FEMA APPEAL DOCUMENT

City of San Bruno

Moffatt & Nichol

Date: August 19, 2016
M&N Job No: 9319

Figure 4: Preliminary FEMA Flood Zones (FEMA, 2015)

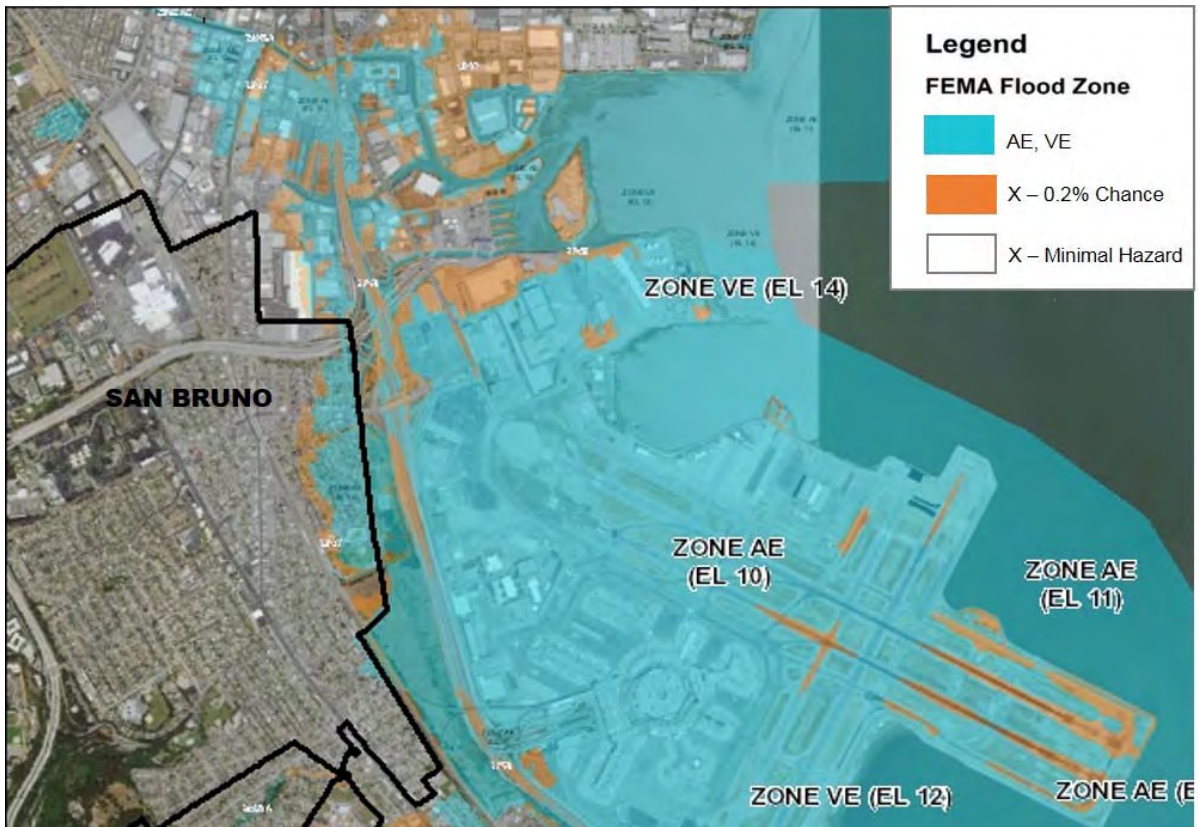
The City is filing a written appeal to contest the flood zone boundaries for portions of San Mateo County as scientifically incorrect. FEMA's methodology of mapping all areas below the BFE contiguous to a flooding source, regardless of duration of elevated water levels and terrain changes, is believed to provide a too conservative estimate of flood extents within the City of San Bruno. The following discussion will detail the basis of this appeal.

FEMA's methodology of mapping all areas below the base flood elevation contiguous to a flooding source is appropriate for areas where extreme water levels are the result of large storm surges associated with hurricanes that can last for several hours or even days. During these events, flood waters could be elevated sufficiently long to flood all areas below the base flood elevation. However, extreme water levels within San Francisco Bay are typically not a result of storm surge, rather, are "influenced by El Niño, setup, and tide" (FEMA 2005). For the 9414750 Alameda Tide Gauge, which has been in service since 1939 (NOAA 2016), one of the highest recorded water levels of +9.2 feet NAVD88 resulted from the combination of a King Tide (+7.5 feet NAVD88 astronomical tide) in a strong El Niño year (1983). Because these extreme events follow a semi-diurnal tidal cycle, the 1% annual chance flood level in the Bay will only be elevated for a few hours and recede as the tide ebbs. Figure 5 shows the difference in water levels one hour before and after the maximum water level, indicating that elevated water levels within the Central San Francisco Bay are only experienced for a limited time.

The duration of elevated water levels becomes increasingly important for areas such as the City of San Bruno, which is offset from San Francisco Bay. Flooding from the Bay must travel through channels or overland in order to inundate this area. The new hydrodynamic analysis conducted by M&N is to apply similar unsteady flood events over the area, using a time series from extreme high tide events and elevated to FEMA 1% and 0.2% SWELs. The unsteady state modeling will be discussed in Section 3 with more details. In summary, the hydrodynamic modeling performed in this study shows that the water level is not elevated long enough to flood the extent of areas shown in the preliminary FIRMs.

Figure 17: Comparison of Flood Areas Between Preliminary FIRM (left) and Alternative Analysis Results (right) for the 1% Annual Chance Flood

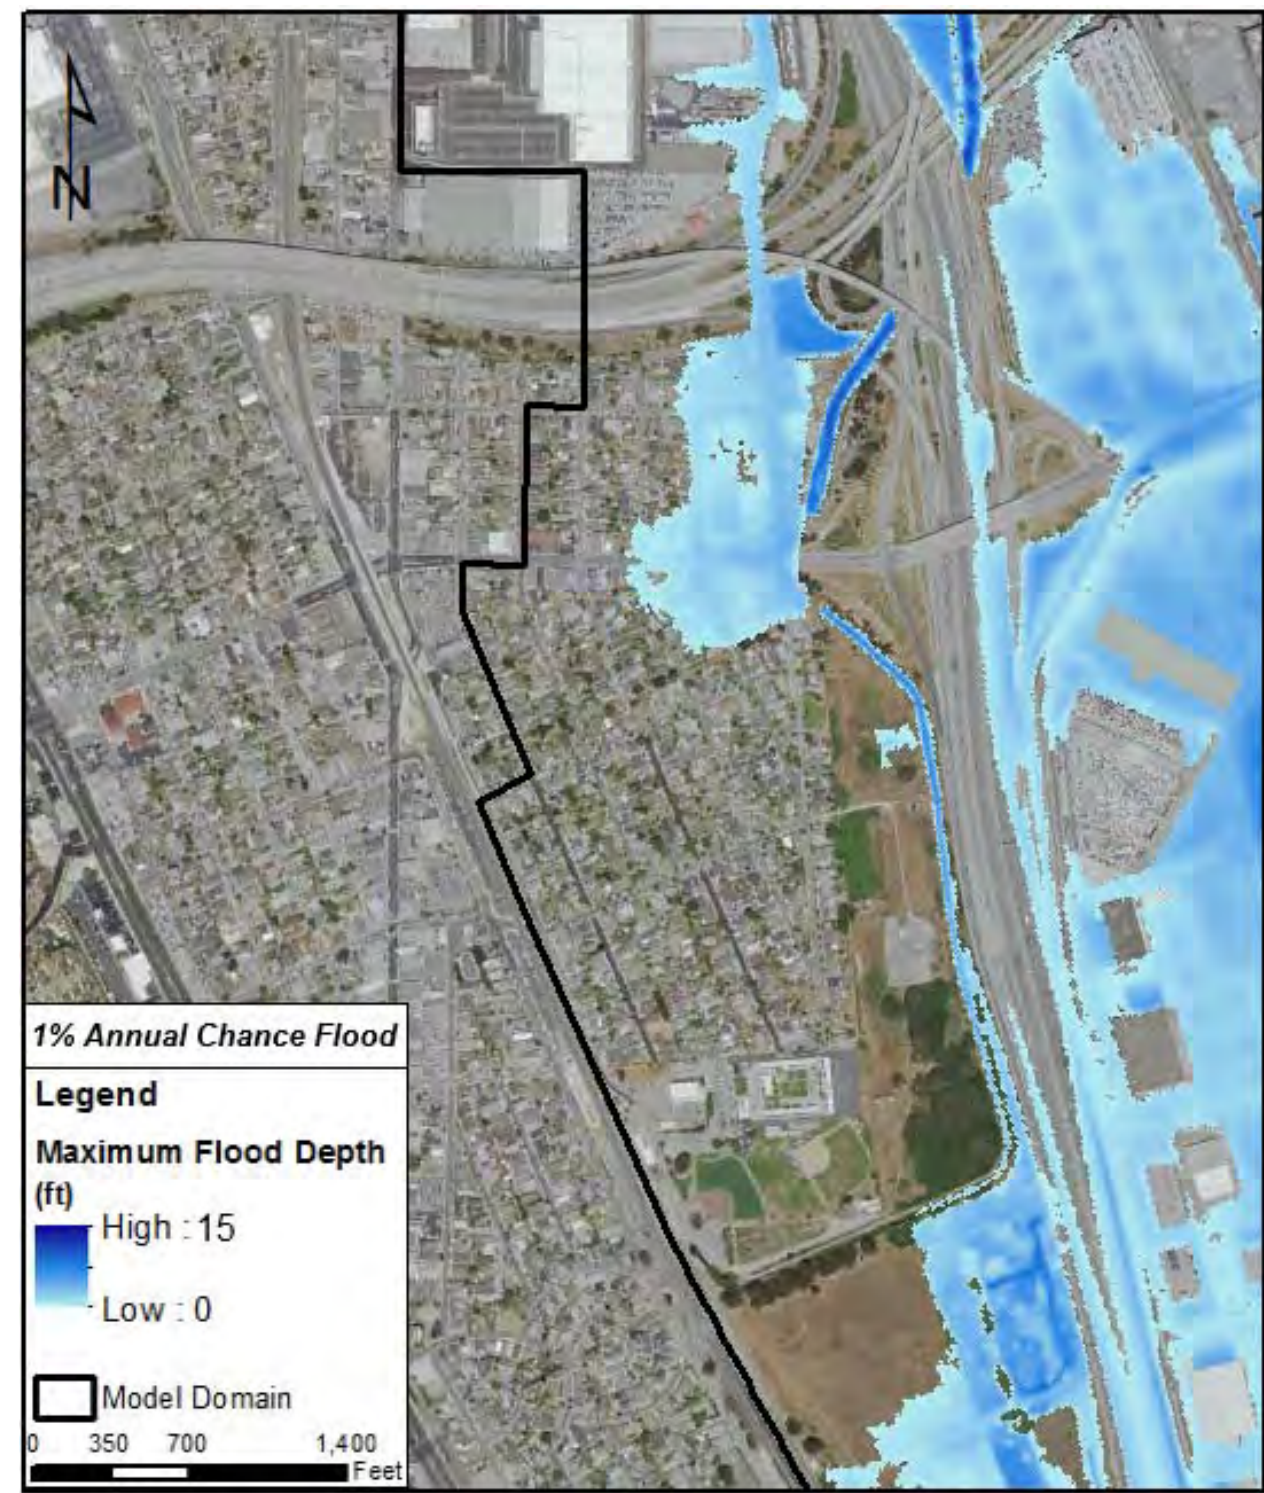
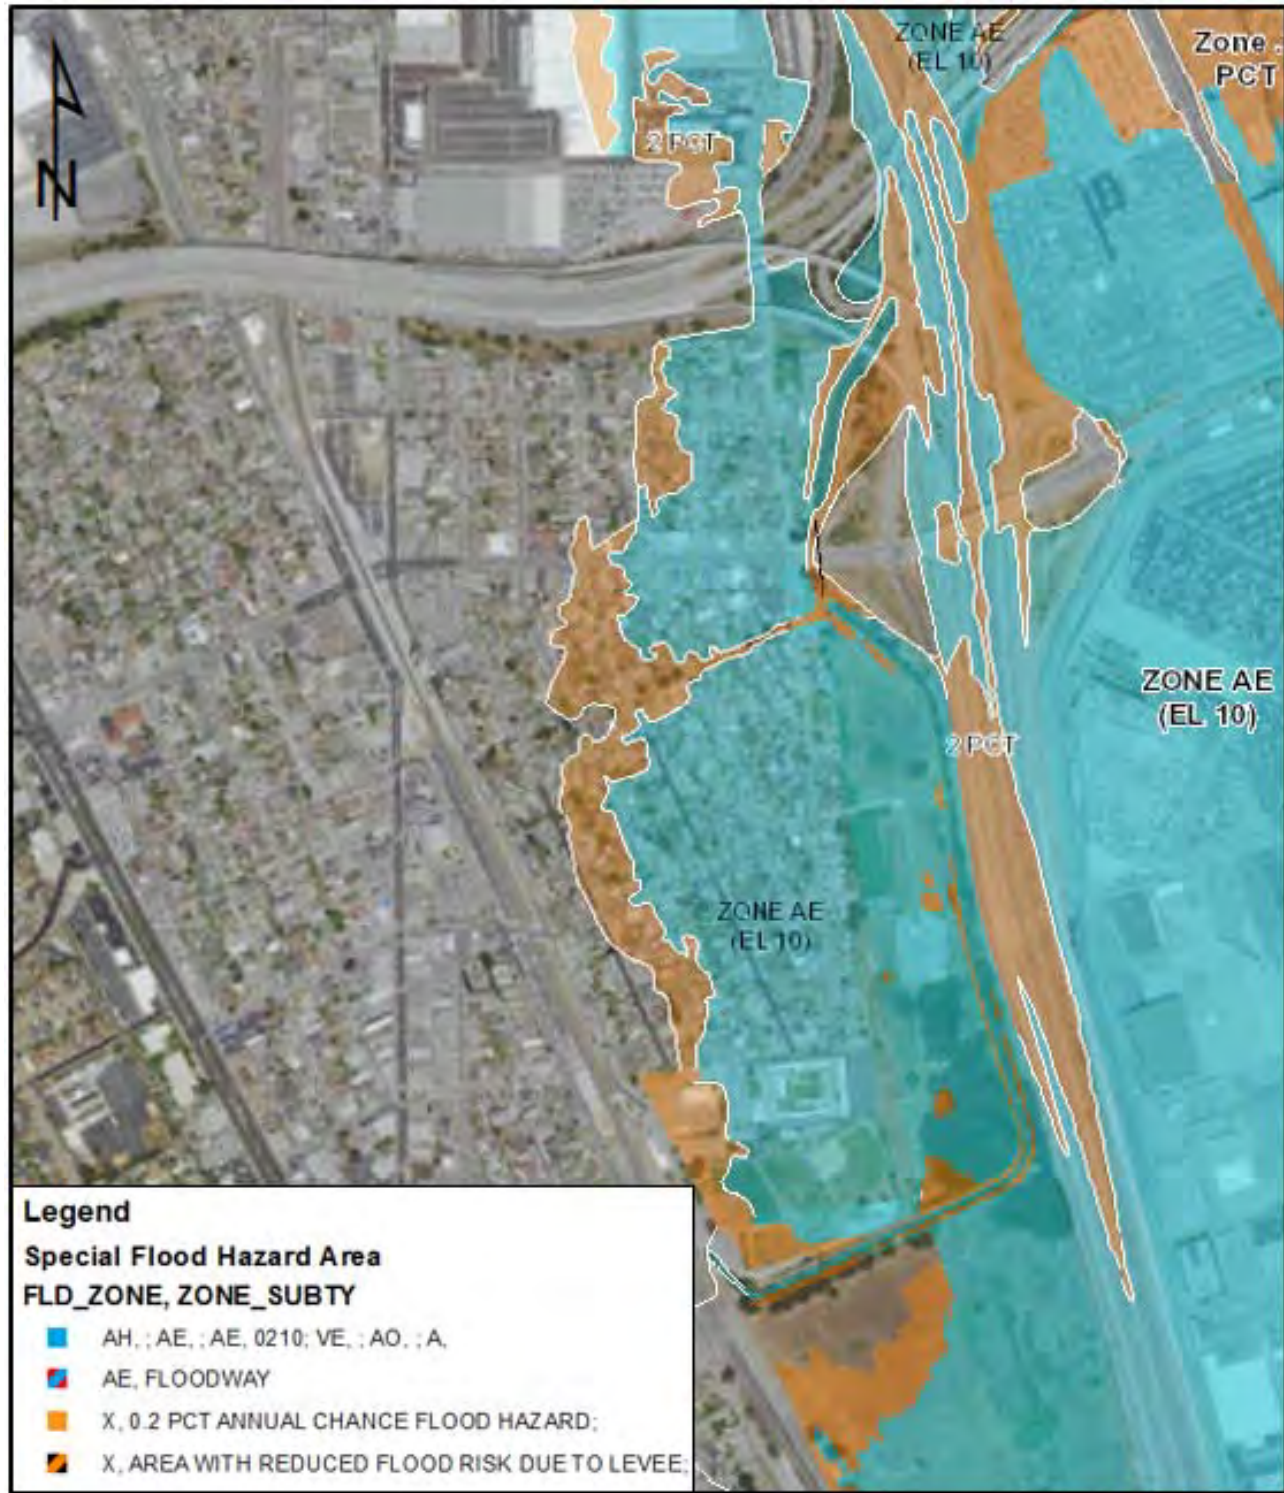
Figure 17 compares flood hazard areas between FEMA's preliminary FIRM Zone AE in the City (aqua blue shaded area on left image) and the alternative analysis results. With the alternative analysis method of using an unsteady 2D model, the flooded areas within the City jurisdiction will be limited to the Belle Air neighborhood. The flooded area in south of Pine Street is significantly reduced compared to the FEMA preliminary FIRM. Hence, it is evident that using a scientifically more accurate alternative method accounting for the duration of the flood and the terrain impacts has a significant impact on the area that would be flooded during the 1% annual chance flood.

Figure 18: Comparison of Flood Areas Between Preliminary FIRM (left) and Alternative Analysis Results (right) for the 0.2% Annual Chance Base Flood

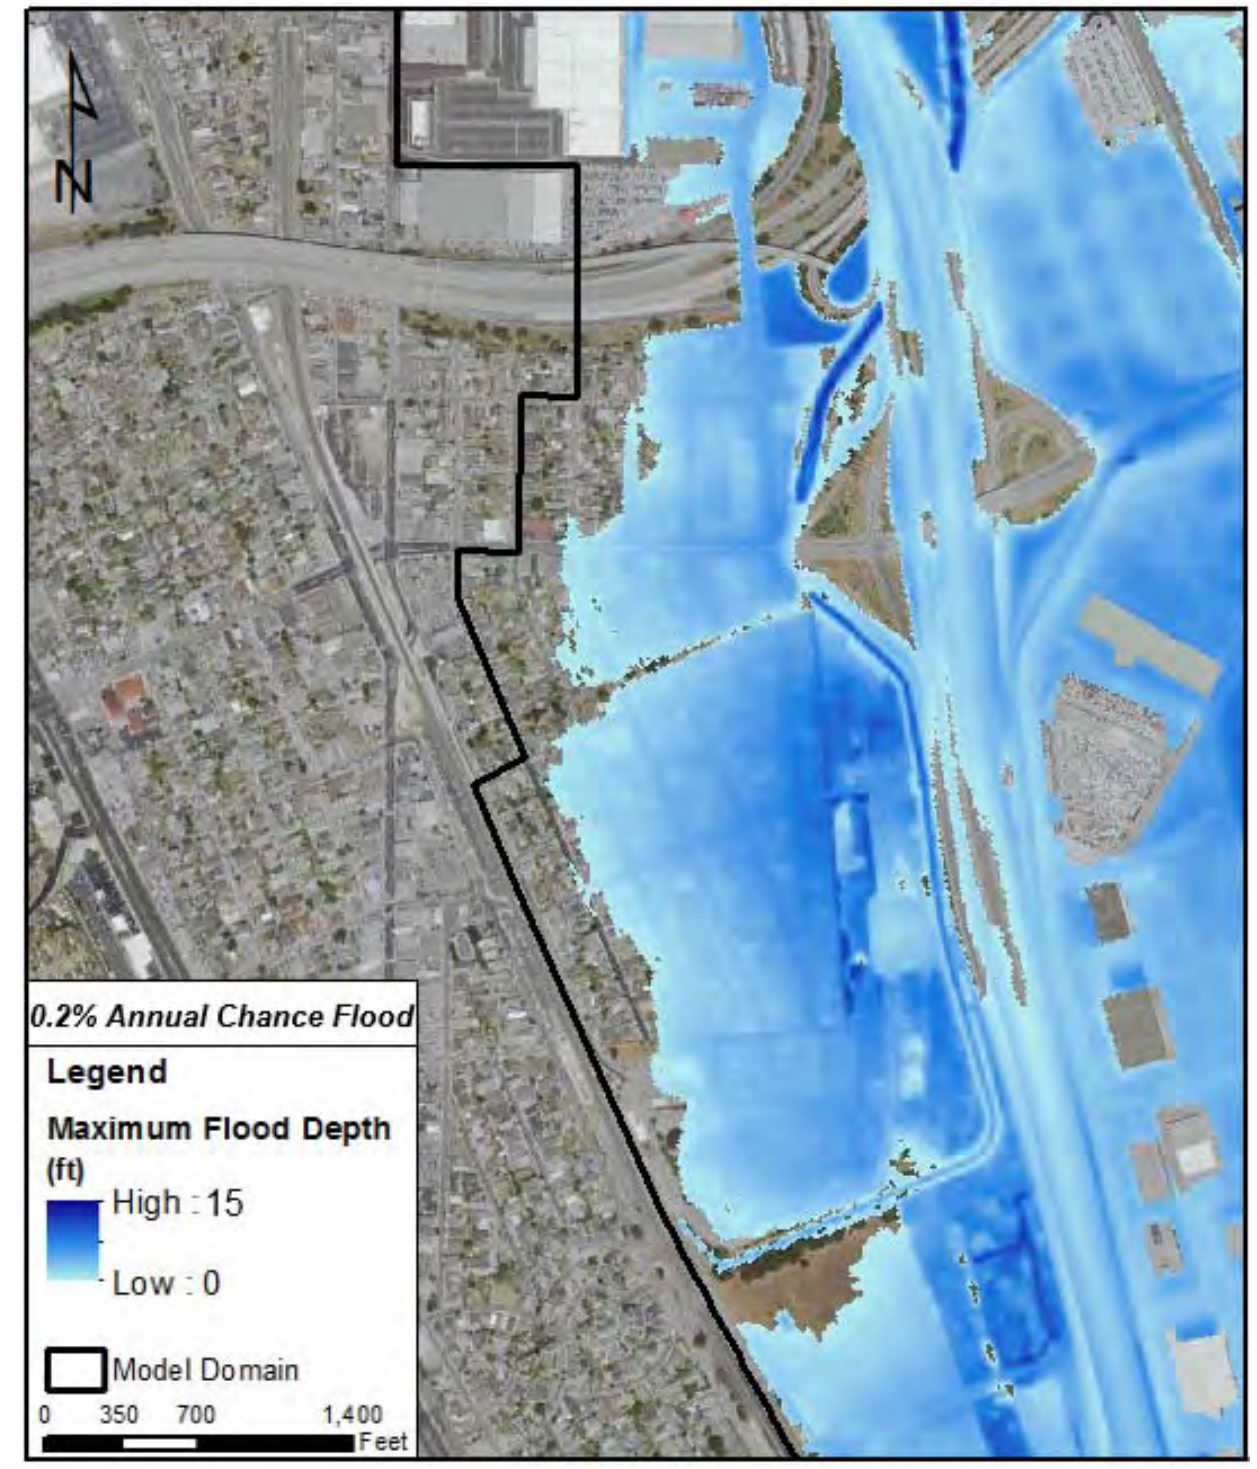
Figure 18 compares the flooded areas between FEMA's preliminary FIRMs (boundary of orange shaded area) and the alternative analysis modeling results for the 0.2% annual chance flood (SWEL of +12 feet NAVD88). Comparison indicates that the extent of flooding for this scenario is similar. This is because when the duration of high elevation gets long enough that the unsteady state modeling approach becomes similar to FEMA's steady state approach. The flood hazard area shows close alignment to the contour of +12 feet NAVD88.

Figure 19: FEMA Preliminary FIRM (Left) and Revised Inundation Map under 1% Annual Chance Flood (Right)

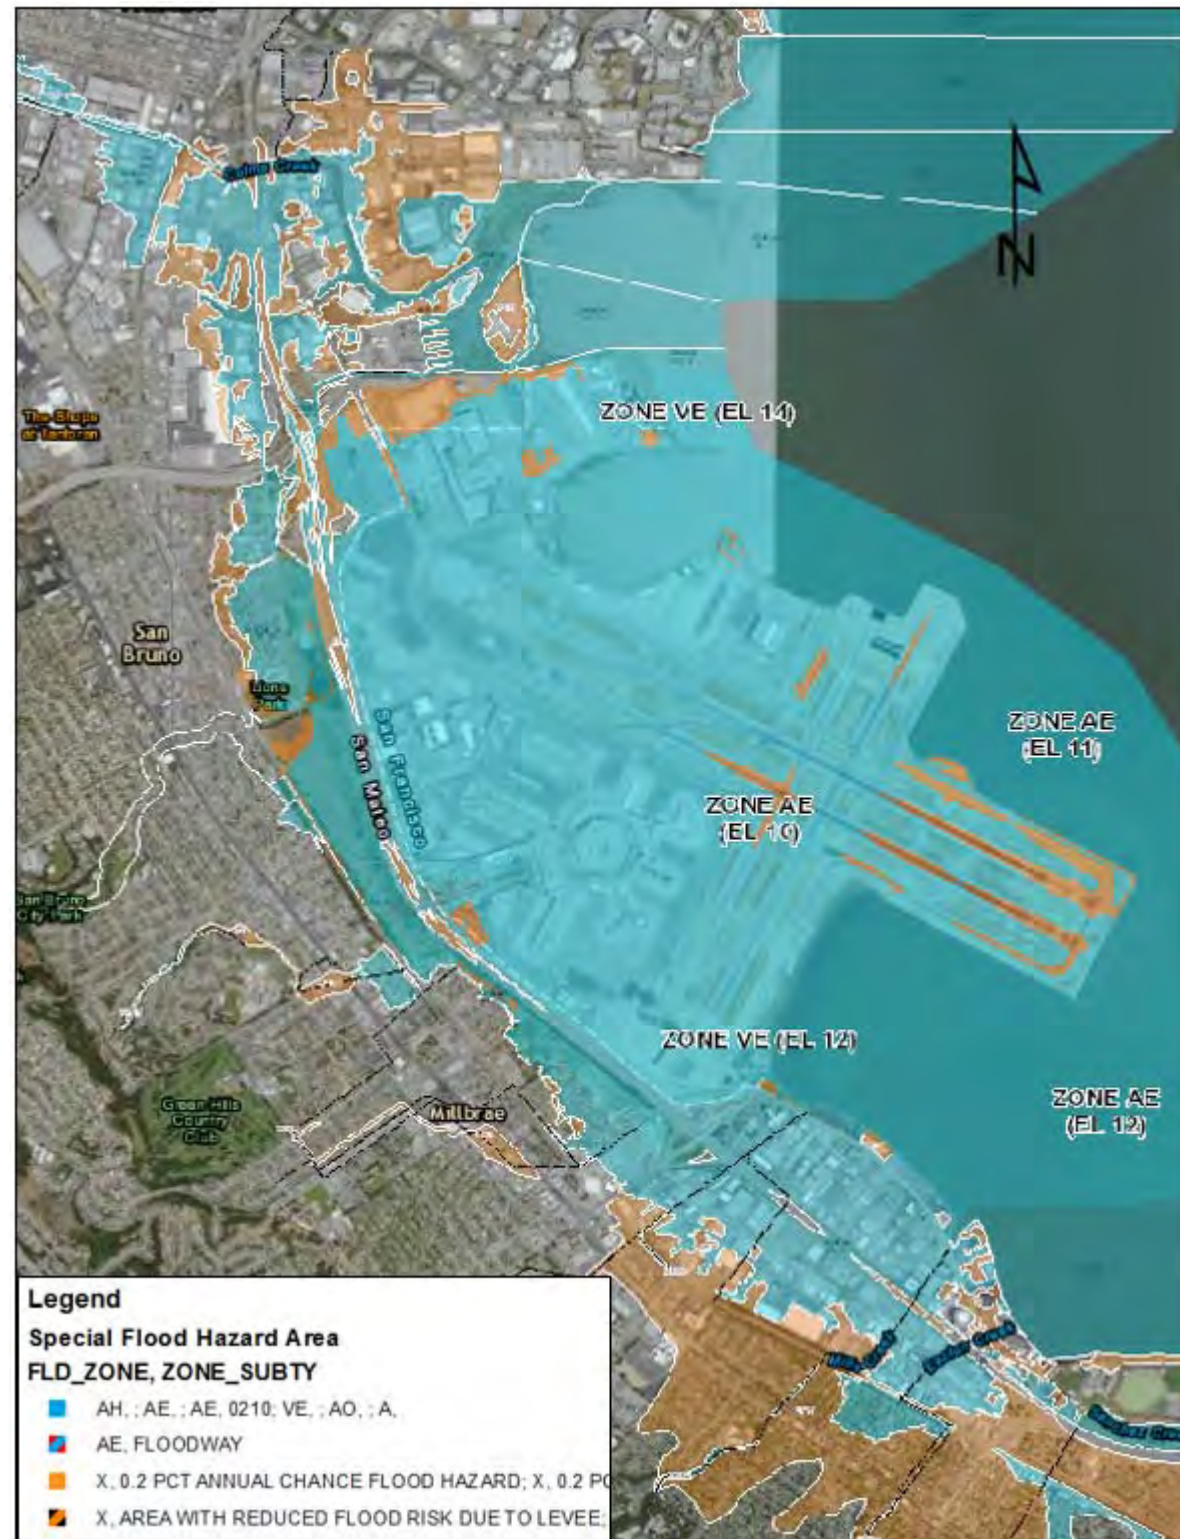
According to FEMA FIRM zone definitions described in Section 1.1, Zone AE are areas of inundation by the 1% annual chance flood with wave heights and runup levels less than 3 feet above the SWEL. Due to the fact that Belle Air neighborhood is located inland and is not subject to wave effects, the modeled inundation area under 1% annual chance flood defines the BFEs and Zone AE boundary for the Belle Air neighborhood. Similarly, Zone X areas are defined as areas that are subject to inundation during storms that are larger than the 1% annual flood but less than the 0.2% annual chance flood. Figure 19 and Figure 20 show the revised inundation areas under 1% and 0.2% annual chance floods with the more accurate alternative analysis.
